Docket Item # 6
BAR CASE# 2009-0032

BAR Meeting
March 25, 2009

ISSUE: Alterations
APPLICANT: Brenda and Brian Maday
LOCATION: 403 North Fayette Street
ZONE: RB/Residential

The Applicant is requesting approval of a Certificate of Appropriateness for the installation of a painted, wood, pedimented door surround and a wood cornice on the front elevation of the townhouse located at 403 North Fayette Street.

Figure 4: 1961 Construction Drawings

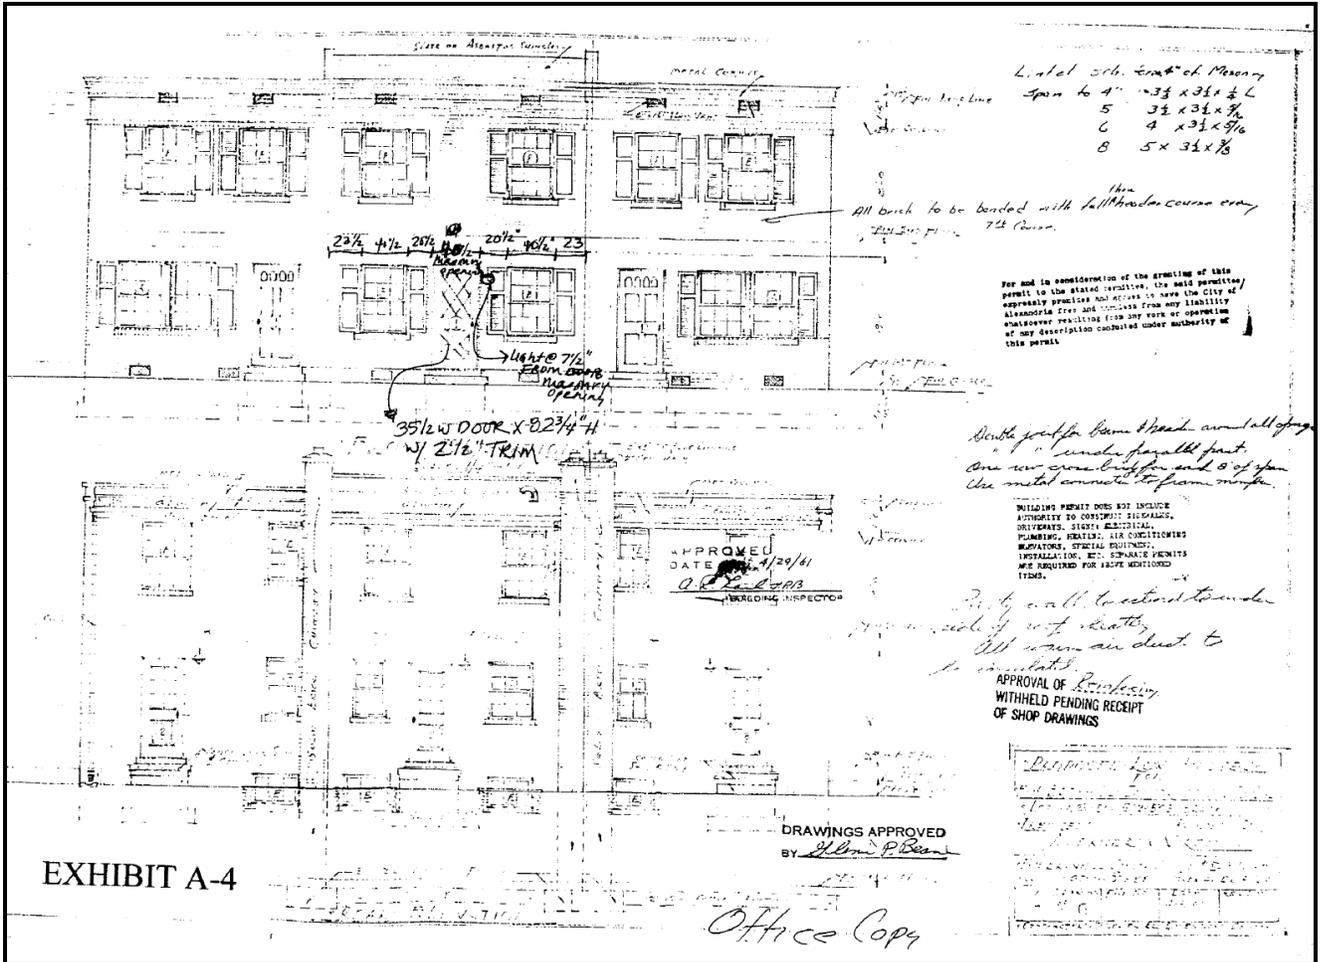
The subject proposal is requesting the installation of a wood pedimented portico, and wood molded cornice onto this early 1960s brick townhouse. The Applicant has provided the Board with the original 1961 construction drawings (see Figure 4), which illustrate some of the as-built details including the absence of ornamentation around the entry, and the existing fenestration alignment. The drawings also indicate the intent of the architect for these units to also have a molded metal cornice and 6/6 double-hung windows flanked with two-paneled louvered shutters, even though these elements were never installed.

That the Applicant utilize the 1961 construction drawings as a basis for their revised design and install a molded metal cornice rather than the wood cornice as proposed, and that the Applicant consider installation of wood, two-paneled, louvered shutters flanking each of the four front windows as shown on the 1961 plans. The shutters must be sized to correspond to the width of the window openings, and be installed by utilizing screws which penetrate into the brick's mortar, thus not to damage the exterior brick surface.

Figure 5: Proposal

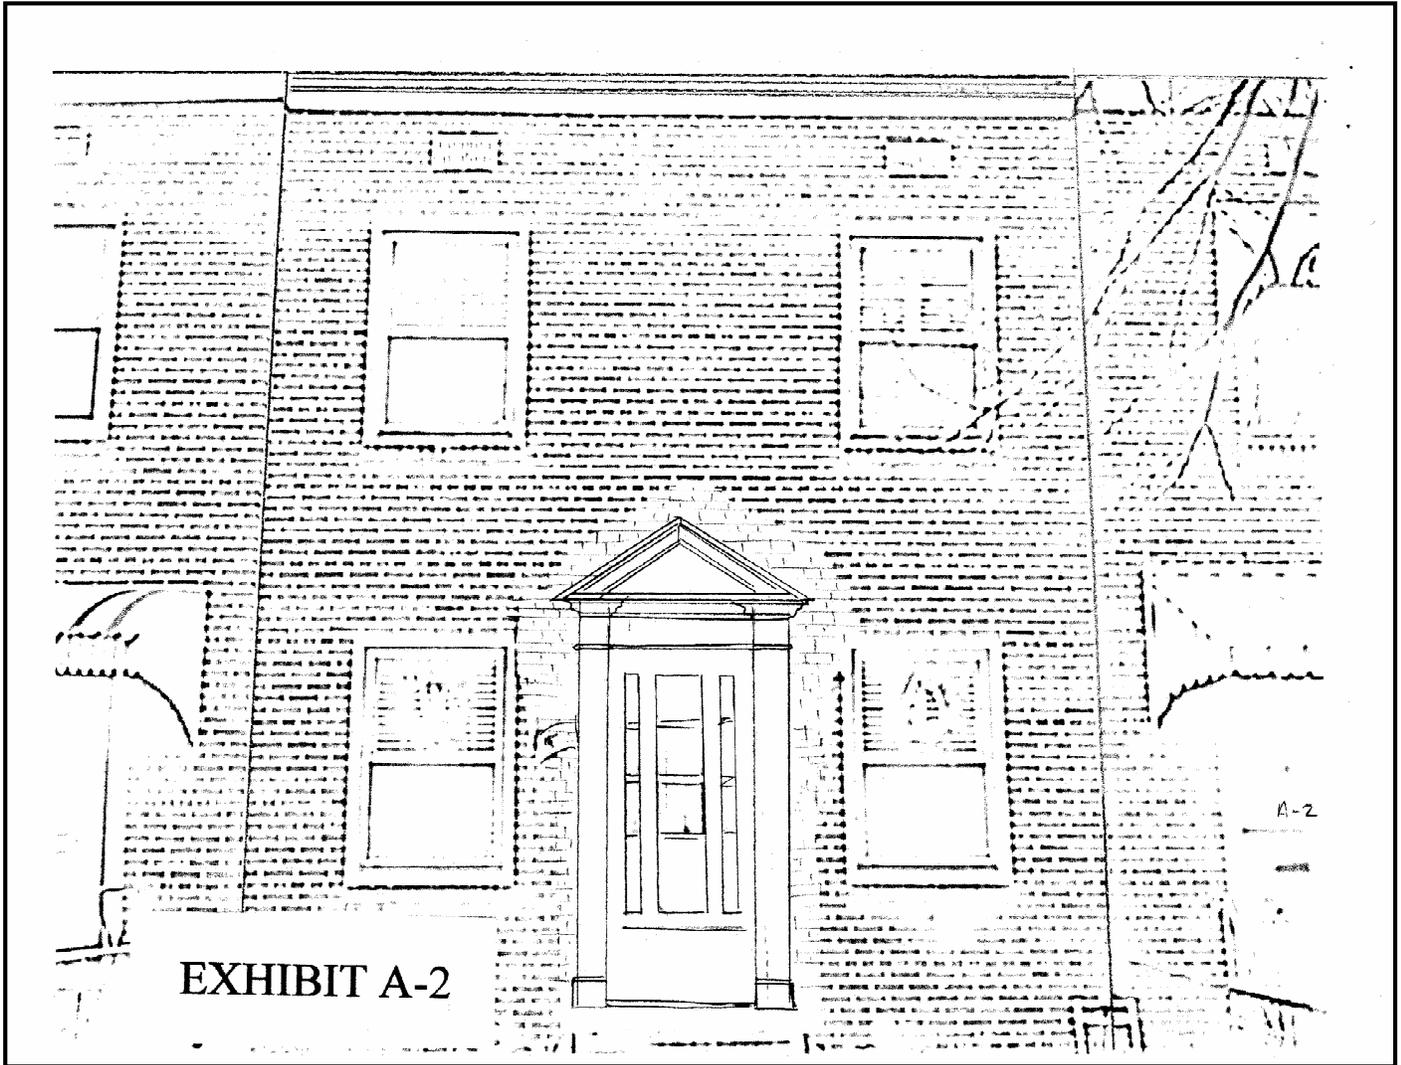
Staff recommends that the application be deferred for restudy, as the Applicant's request for a pedimented entry is a high-style, conjectural feature that is not original to the building. The addition of this element would be creating a false sense of historical development and would negatively impact the architectural integrity of this mid-twentieth century building. Staff recommends that the Applicant install a molded metal cornice as identified in the original 1961 construction drawings rather than the wood cornice proposed. Staff also suggests that the Applicant may consider installing fixed, two-paneled, louvered shutters on the front elevation, as identified in the original 1961 construction drawings. It should be noted that, while the design guidelines strongly discourage decorative wood shutters that are not operable, due to the age of the townhouse and the fact that decorative wood shutters were shown on the 1961 plans for the building, in this case non-operable wood shutters would be appropriate and as such any proposed shutter installed on this building should be affixed to the elevation through the use of screws into the brick's mortar joints.
